# HISTORIC AND DESIGN REVIEW COMMISSION

October 04, 2017

**HDRC CASE NO:** 2017-486  
**ADDRESS:** 310 TRAIL  
**LEGAL DESCRIPTION:** NCB 6391 BLK LOT 12 & NE PT OF 9  
**ZONING:** MF-33 H  
**CITY COUNCIL DIST.:** 1  
**DISTRICT:** River Road Historic District  
**APPLICANT:** Gaspar Rivera/Poma Properties  
**OWNER:** Poma Properties  
**TYPE OF WORK:** Window replacement, fenestration modifications, porch modifications

Current View

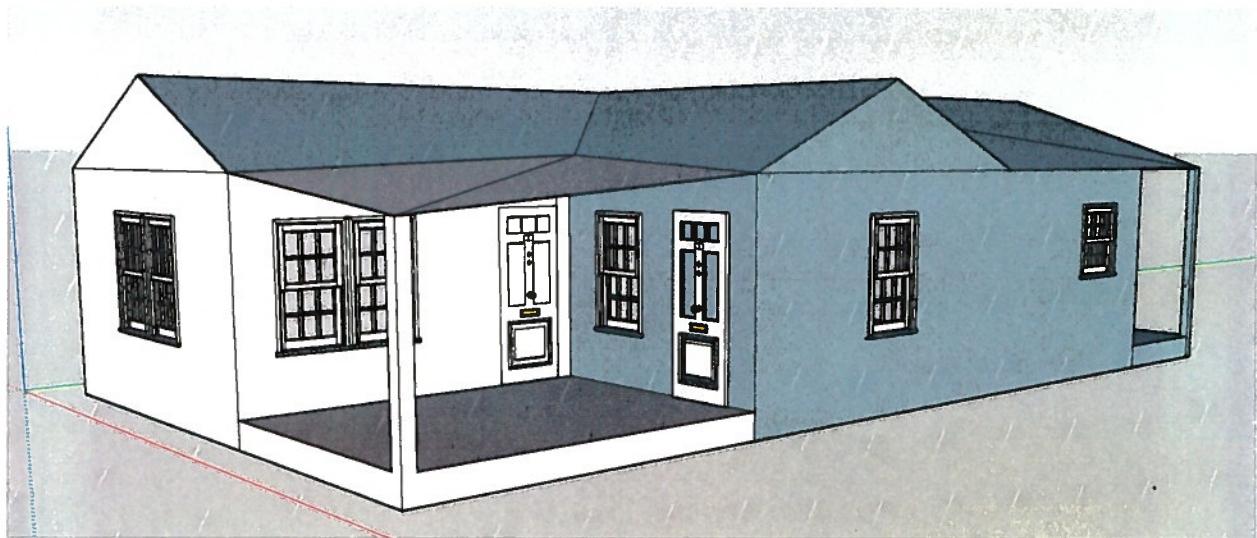
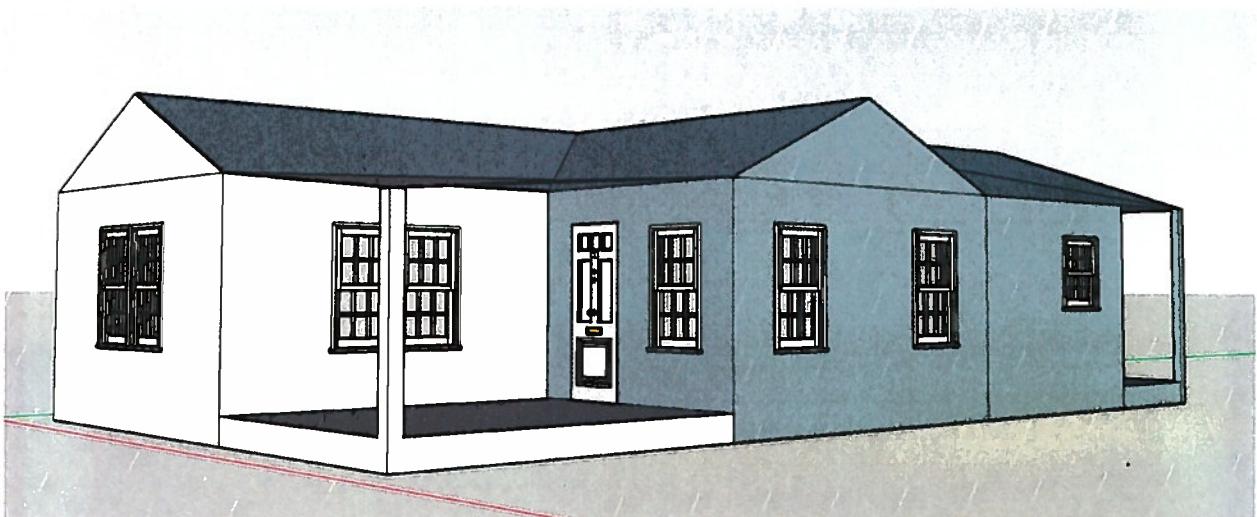
- d. ENTRY OPENING MODIFICATIONS – The applicant has proposed to modify the existing front entryway configuration. Modifications include: the removal of the door on the east facing façade; shifting two windows slightly on the east facing façade; and swapping the location of a window and a door on the north facing façade. According to the Historic Design Guidelines, historic openings should be preserved. However, based on the home's previous configuration on Sanborn Maps, this house was likely converted to a duplex sometime after the 1950s. Staff finds the proposal acceptable.

Item 3, Staff recommends approval of the entryway modifications based on finding d.
